HYDROLOGY

L18/D39
THREE PLANS

FOUR-PLEX FOR VAN TILLOTSON

DRAINAGE PLAN

DRAINAGE PLAN

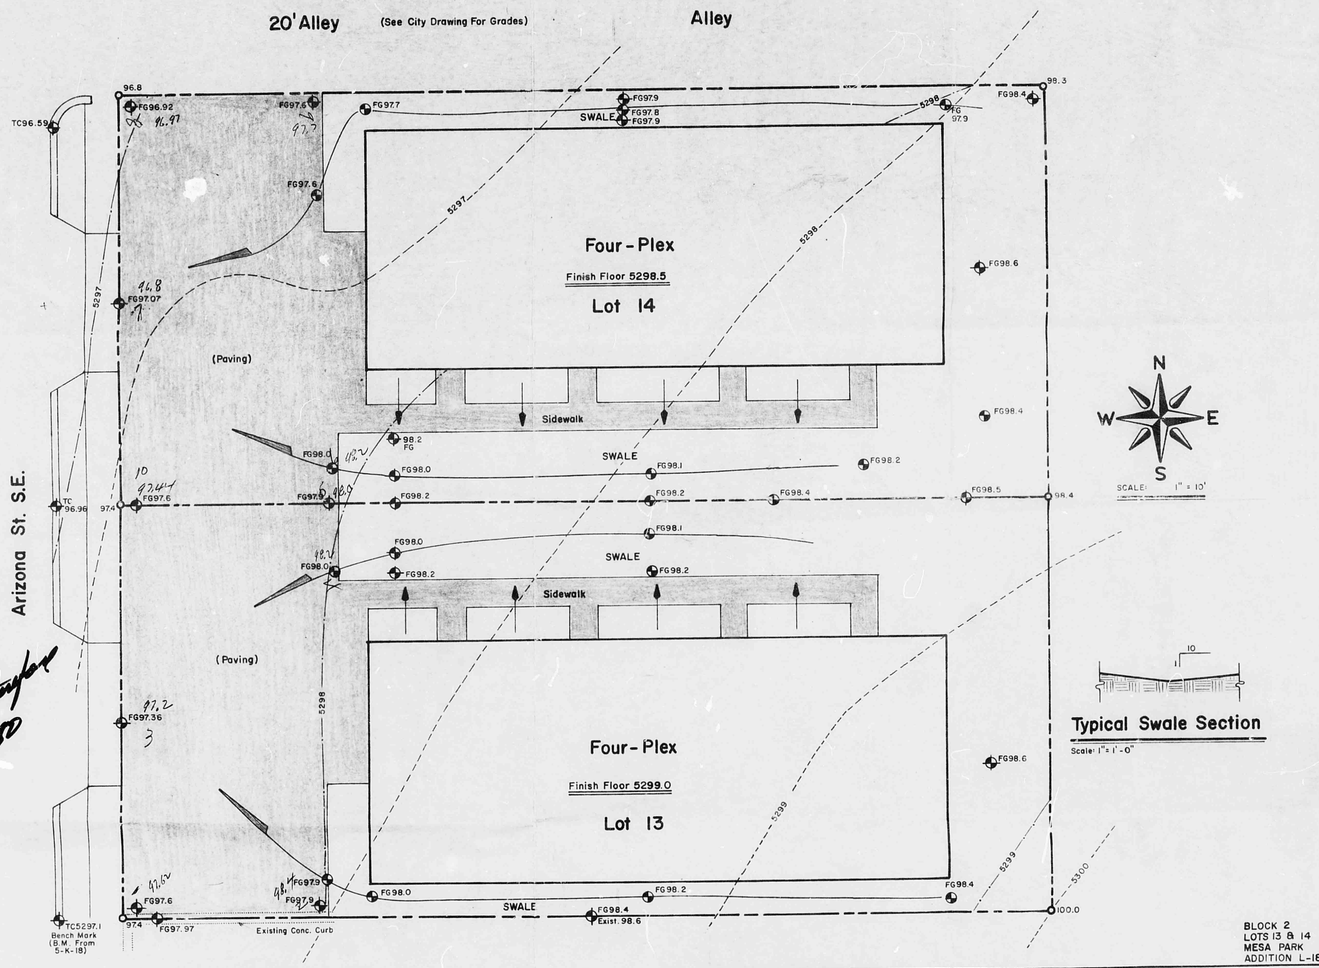
As long as elevation at PL is more than 1½ feet above top of curb I can accept it. This seems to be greater than that. Anyone of HDR, 11-17-80
